AGENDA
PLANNING COMMISSION
116 WEST NEEDLES
BIXBY, OKLAHOMA
March 18, 2013 6:00 PM

MINUTES
PLANNING COMMISSION
116 WEST NEEDLES
BIXBY, OKLAHOMA
January 21, 2013 **6:00 PM**

To: Bixby Planning Commission
From: Erik Enyart, AICP, City Planner
Date: Thursday, January 10, 2013
RE: Report and Recommendations for:
BCPA-7 – Comprehensive Plan Amendment – JR Donelson, Inc. for Clinton Miller and Roger Metcalf,
PUD 74 – “RiverLoft ADDITION” – JR Donelson, Inc., and
BZ-362 – JR Donelson, Inc. for Clinton Miller and Roger Metcalf

To: Erik Enyart
From: Jared Cottle *JWC*
CC: Bea Aamodt
File
Date: 02/28/13
Re: Bixby Landing 2nd Preliminary Plat Review

RiverLoft

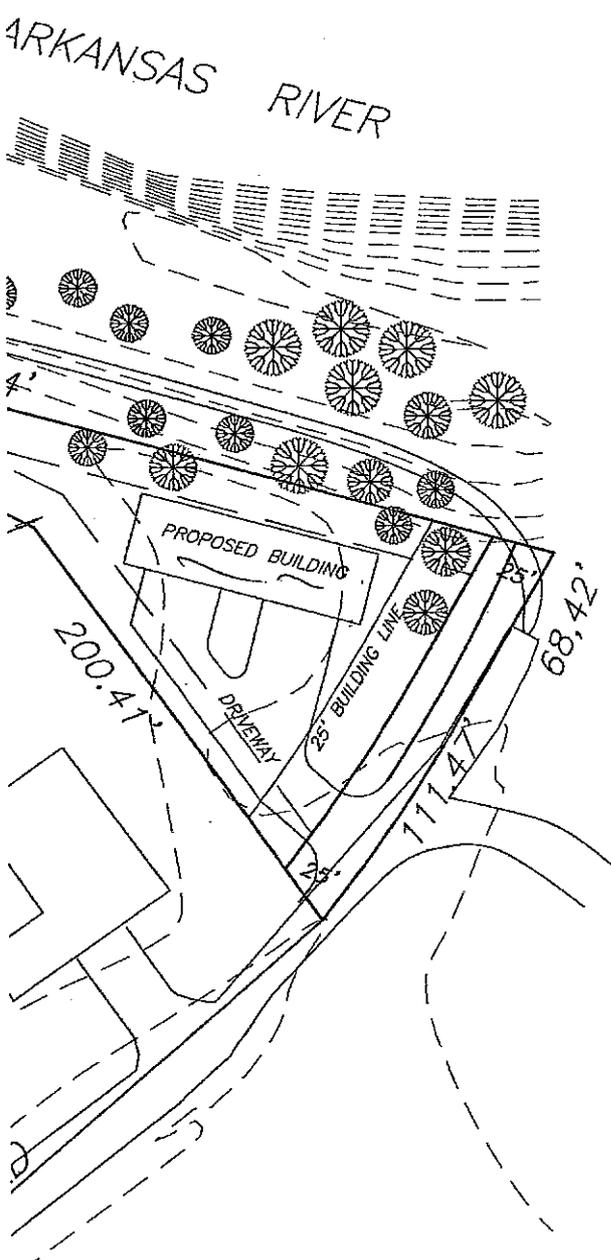
1. Entire tract of approximately 8 acres is not included in the PUD. PUD does not show the relationship between the 0.61-acre area requested for approval and the balance of the approximately 8-acre subject property tract. Although adequate information is not provided, it appears, based on existing dimensions and configurations, that the balance of the approximately 8-acre subject property tract would not maintain the minimum 200' lot width (impossible without a front lot line, which is impossible without street frontage per definitions in Section 11-2-1). Subdivision Regulations Section 12-3-2.H requires access to public streets, and platting the 0.61-acre tract apart from the balance of the tract would cause the balance to be separated from the public street, or "landlocked." Regardless of code prohibitions, landlocking tracts of land is not good land use or development policy.

2. Item numbered 3 under Residential Area Policies on page 33 of the Comprehensive Plan provides, "Residential development within areas subject to periodic flooding will be strongly discouraged and regulated..." The subject property is entirely within the 100-year (1% Annual Chance) Regulatory Floodplain, and part of it may be in the Floodway. Placing residents on the bank of the Arkansas River, in an area that history has proven has flooded' [footnote: Water Management Analysis Report, Flood of September - October 1986, Appendix B, U.S. Army Corps of Engineers, Tulsa District, August 1987, Plate A-10.J and FEMA's models show will likely flood during the next 1% Annual Chance event, is not good land use and development policy. Even if the land is elevated above the 100-year Floodplain, the subject property would become an "island" during such an event, unable to be exited or reached in emergency situations. Also, even if elevated above the 100-year Floodplain, it would still likely be in the 500-Year (0.2% Annual Chance) Floodplain, meaning it would flood during such events. The 1986 flood event was larger than a "100-year," 1% Annual Chance event. The former residential subdivision

3. Item numbered 1 under Residential Area Policies on page 33 of the Comprehensive Plan discourages residential development along major street frontage, stating, "Residential lot arterial street frontage will be avoided and residential lot collector street frontage will be discouraged in development design" (emphasis added). Although it is not a highly-trafficked street at its north dead-end, and houses had traditionally fronted upon it in Riverview Terrace Addition, Privett Addition, Midland Addition, and [the Original Town of] Bixby, Riverview Road is designated a Minor Collector street on the Bixby Comprehensive Plan Land Use Map.

4. Based on a site inspection November 27, 2012, Staff did not observe evidence of utility service to the subject property. Critical utilities include water, sewer, and electricity. Ancillary utilities include natural gas, telephone, and cabled communications. The City Engineer's memo indicates water and sewer service will be extended [to the subject property]. PUD Section B.[6].c does not describe utilities other than water and sewer. Reference Bixby Comprehensive Plan Residential Area Goals item numbered 2 on page 32 and Residential Area Objectives item numbered 3 on page 33. Generally speaking, it is not good land use and development policy to grant development approval by means of rezoning lands which are not suited for development due to lack of utility infrastructure.

On the PUD site plan, a sidewalk is not indicated as planned along Riverview Rd., as required by the Subdivision Regulations. PUD Text Section B.[7]. Access, Circulation and Parking provides that a sidewalk along this street is not planned. A Modification/Waiver of the Subdivision Regulations would be required in order to remove the sidewalk requirement along Riverview Rd. Sidewalks are part of complete streets, providing a safe and convenient passageway for pedestrians, separate from driving lanes for automobile traffic. Bixby Comprehensive Plan policy numbered 3 on page 52 encourages enhancing pedestrian transportation by connecting trails to sidewalks. Regardless whether or not these three (3) applications are received favorably by the Planning Commission or City Council, Staff does not recommend removing sidewalk requirements generally.

Residential use here may not be particularly compatible with the Bentley Park Sports Complex, which has elevated floodlights used, and amplified sounds produced at various times, consistent with a large sports park with local, regional, and interstate tournaments booked nearly year-round. The subject property's placement behind the multipurpose building, and next to its storage yard, may not make it a particularly attractive residential location. Further, the proposed building, as indicated on the site plan, would be quite close to the Riverwalk Trail, which can be seen as an amenity for the residents, but the trail itself may be so close that privacy is compromised at times. The site plan does not indicate a privacy fence would be employed.

Staff Recommendation. For all the reasons outlined above, Staff believes that the Comprehensive Plan, the surrounding zoning and land use patterns, and the physical facts of the area do not weigh in favor of the requested amendment and rezoning applications generally. Staff recommends Denial.

UTILITY PLAN
 EXHIBIT E

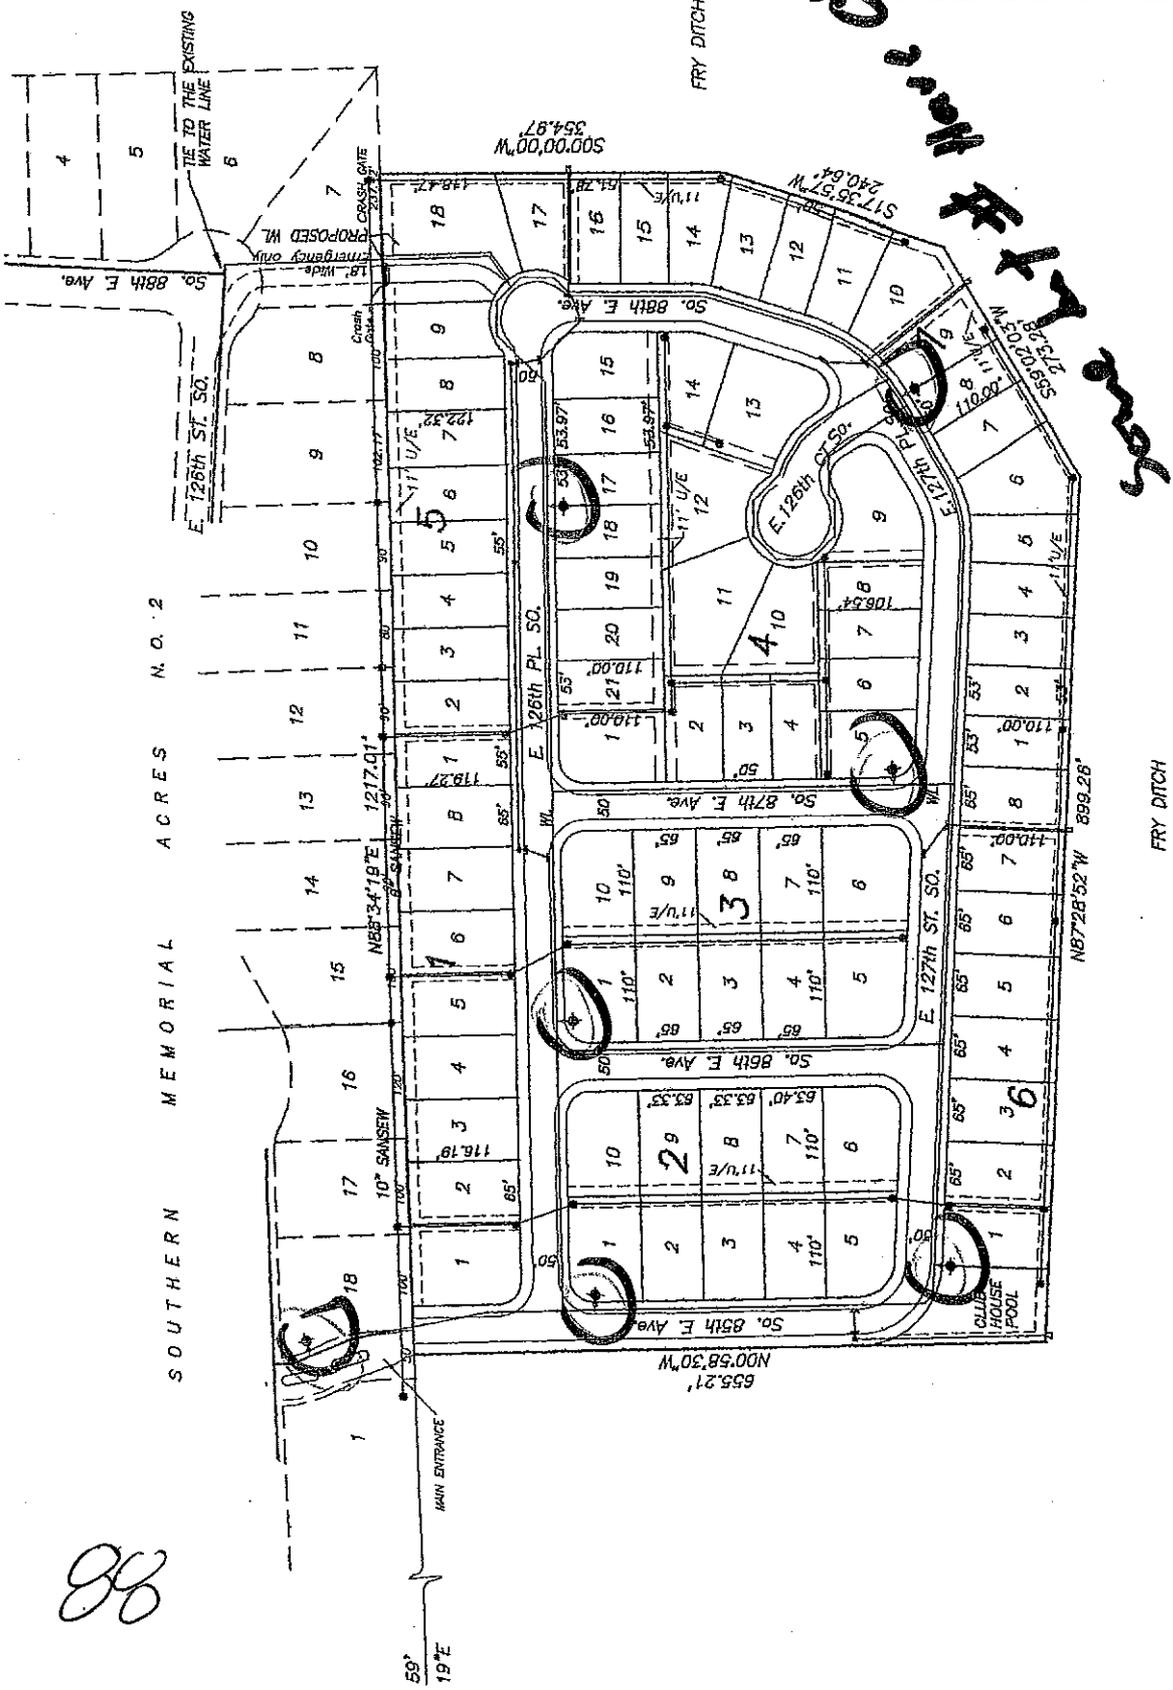
27. Exhibits B, C, D, and E: Please add a North Arrow.
 28. Exhibit B: Please label Development Area A.
 29. Exhibit C: Please identify the subject property.

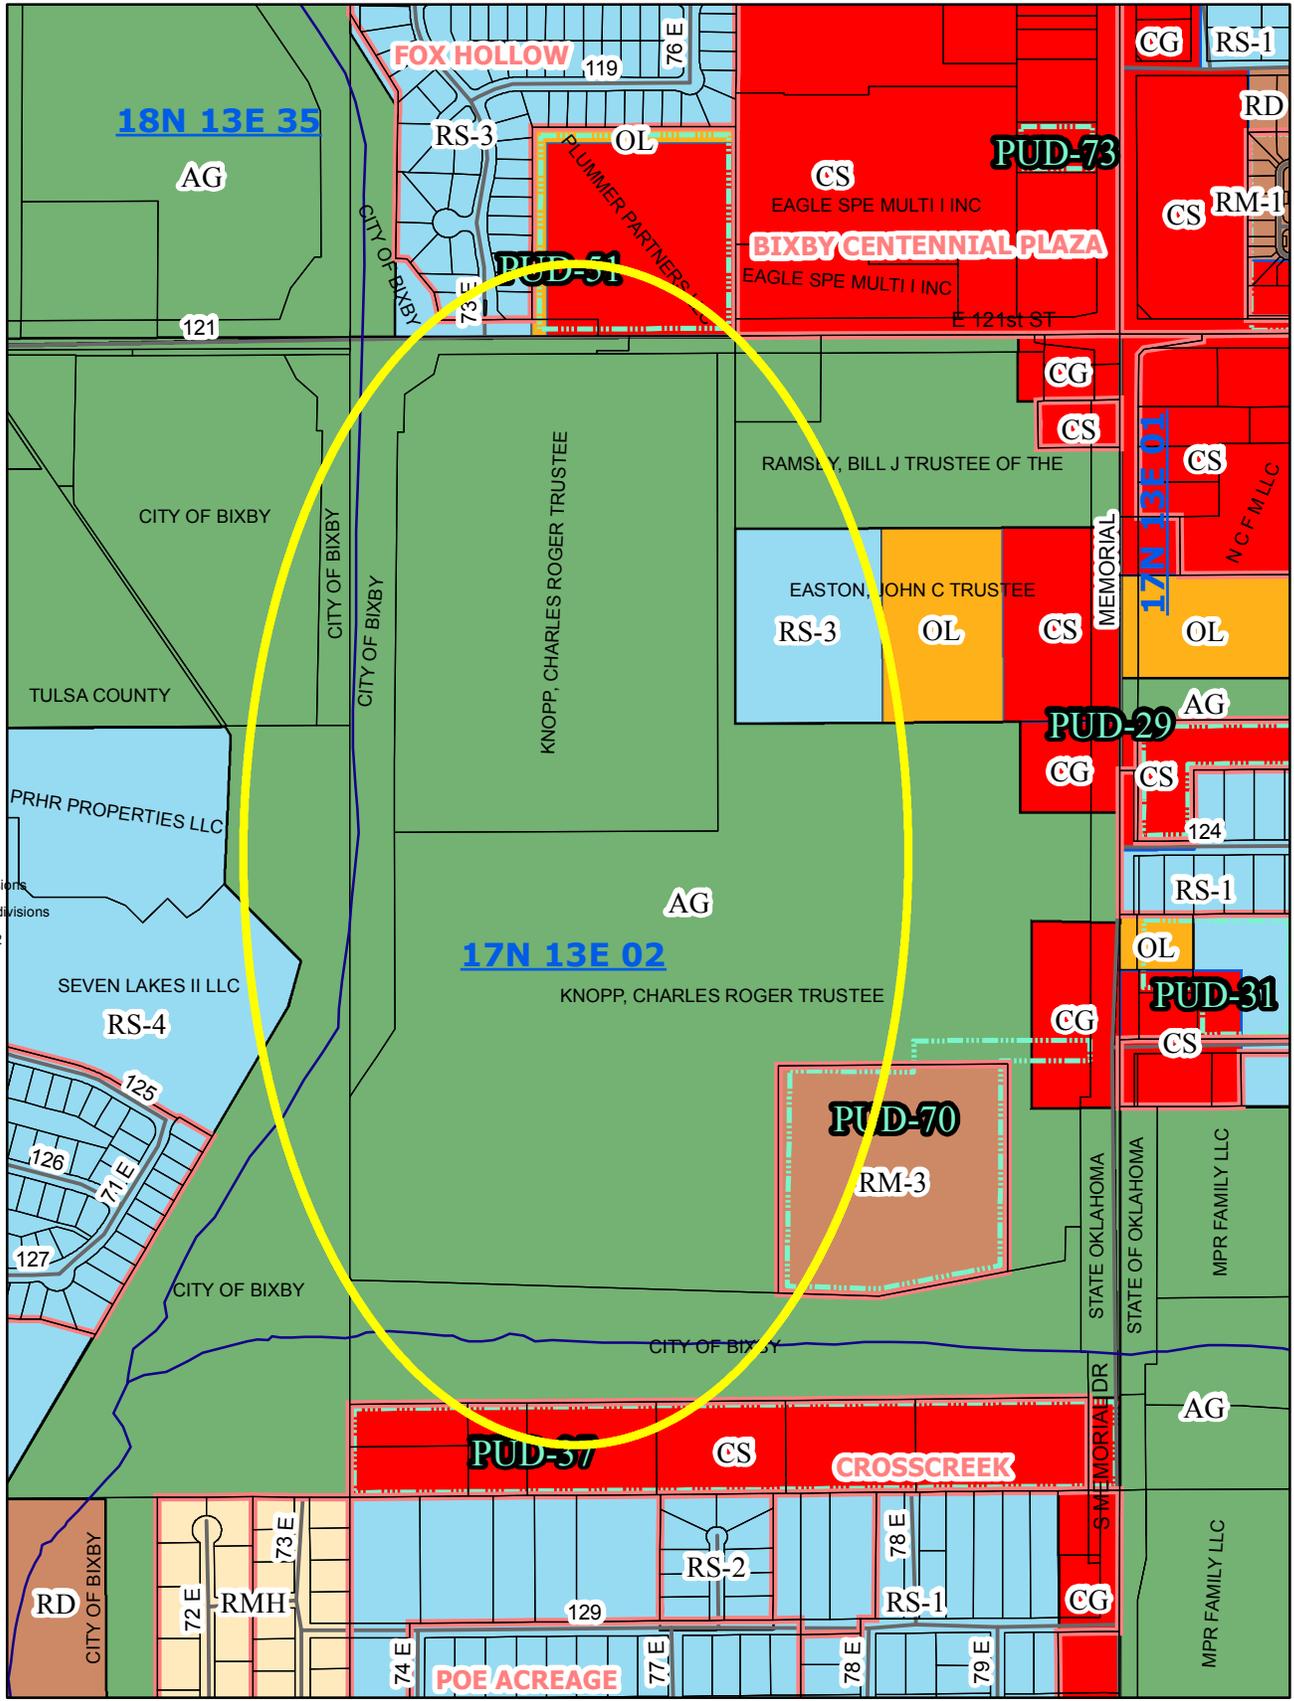
22. Grading details should be provided for Structures An and P.
23. The RCB Transition Detail D should show steel reinforced concrete rather than bricks and mortar to fill voids.

24. Fire Hydrant locations must be coordinated with and approved by the Fire Marshall.
25. Please verify that the hydrant brands specified are consistent with the City Standard Specifications.
26. The Key Map references on Sheet CD26 and there subsequent references on the profiles should be updated with the next submittal.
27. The vertical clearances between water and sanitary/storm crossings should be listed on the profiles.
28. A three-valve cluster should be provided at Sta. 3+27.6 on Line A.
29. Steel casings must be provided for storm sewer crossings on Line A between Sta. 12+00 and Sta. 13+00 as well as between 26+00 and 27+00.

30. Steel casings should be provided for the Line B crossing under the storm sewer and street between Sta. 3+00 and Sta. 4+50.
